Groundwater Protection and Monitoring Program Plan for Rocky Flats Plant

**Manual No.
21000-MP-GPMP**

GROUNDWATER PROTECTION AND MONITORING PROGRAM PLAN

APPENDIX E COMMENT RESOLUTION FORMS

FIGURE 2 19

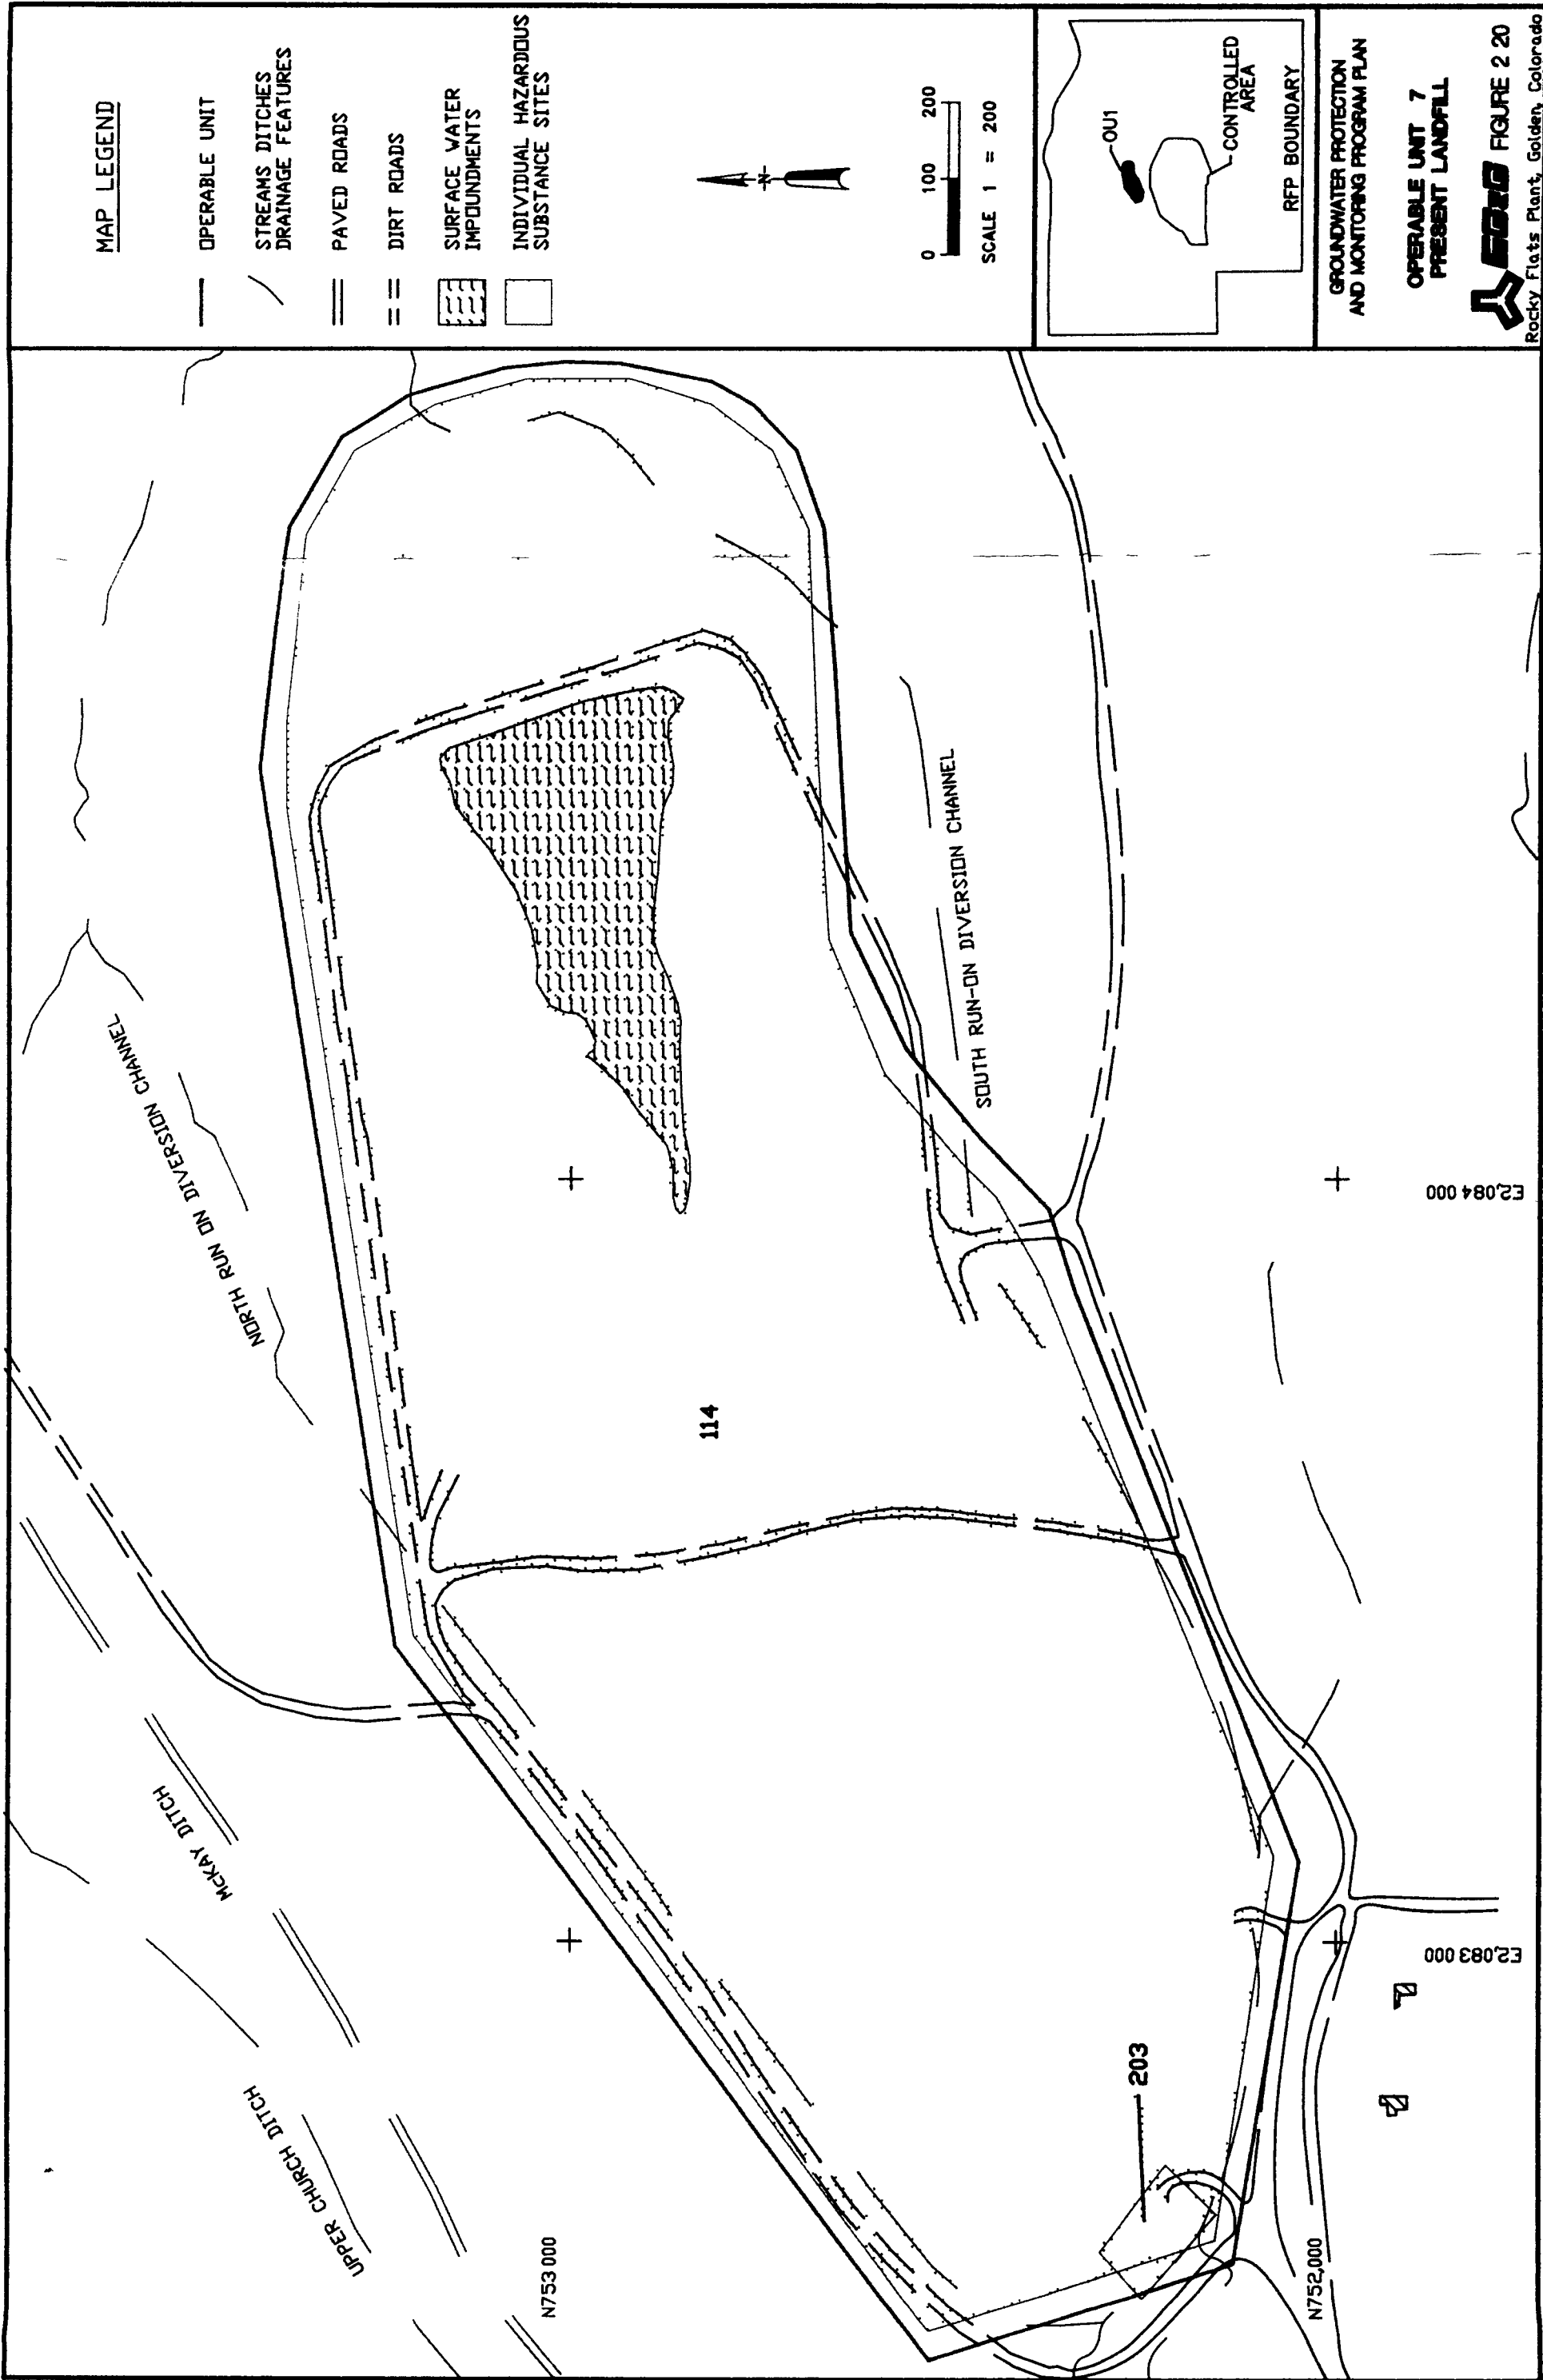
25	Table 2-11	A typo is present in footnote 2	The typographical error was corrected
26	Section 2.3.4	An explanation of the current water diversion structures is necessary. Water transfer from Smart 2 Ditch should be checked for accuracy.	The transfer of water from the irrigation database has been reviewed. Corrections were made on Figure 2-19, (now Figure 2-24)
